Access Compliance Report

Public Rights-of-Way

(Pedestrian Signals)

Intersection ID: N/A	Main Street:	Cross Street: N/A	Location: N/A
ADA ID: F00A5D298F18	Signal Type: Two Push Buttons-Non APS	Overall Compliance: No	Severity Score: BTN 1:N/A BTN 2: N/A No BTN: N/A
Codes/Mitigation Info/Possible Solution		Field Measurements/Component Compliance

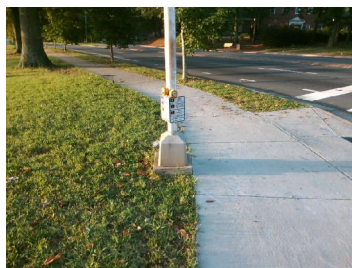
Surveyor Notes: TEXT HT 7/16

PROW/ADA: R410.6, TMUTCD 4e.08, R404.2, R404.3, R404.7.3, R406.2

Possible Solutions: Replace Signal Push Button With APS Button on New Post. Remove & Replace Sign.
